Remarks

Amendments to the Drawings

FIG. 7

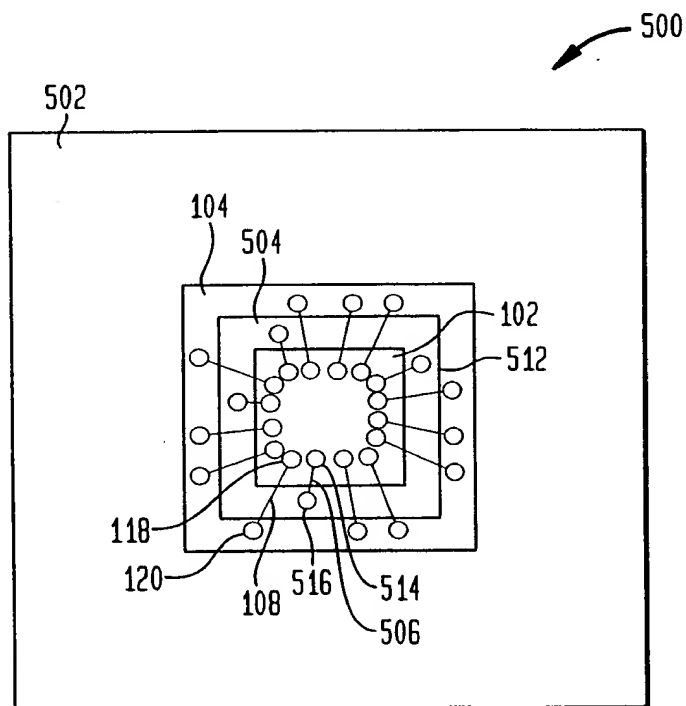
Paragraph 5 of the Office Action states that the drawings were objected to under 37 C.F.R. 1.83(a). Paragraph 5 further states "the 'substrate having a plurality of contact pads on a first surface electrically connected through said substrate to a plurality of solder ball pads on a second surface of said substrate' must be shown or the feature(s) canceled from the claim(s) (See Claims 6, 13 and 38)." Applicants assert that contact pads and solder ball pads were shown in the originally filed drawings, including FIGS. 5-10. However, Applicants have modified Figures 5, 7, 9, and 10 to include examples further showing the claimed features mentioned above, as shown in the concurrently attached three replacement sheets. Example support for these drawing changes is provided in the specification on page 9, which states:

Three annotated sheets are also attached, highlighting the modifications in red. For example, FIGS. 5 and 7 each are modified to show examples of routing and vias for substrate 104. An originally present contact point 120 (e.g., contact pad) for wire bond 108 is shown electrically connected through substrate 104 by vias and routing to a solder ball 106 on the bottom of substrate 104, which is attached to a solder ball pad on the bottom of substrate 104. Original FIGS. 6 and 8 each show a plurality of example contact points 120 on the top surface of substrate 104. FIGS. 9 and 10 each are modified to show additional examples of vias for substrate 104. Furthermore, FIGS. 9 and 10, as originally filed, each show conductive pads (e.g., contact pads) (labeled as conductive pads 904 in FIG. 9) that are electrically connected by routing (not shown) and vias to solder ball pads of solder balls 106.

Figures 5, 7, 9, and 10 have been amended. Replacement sheets and annotated sheets showing corrections in red are attached.
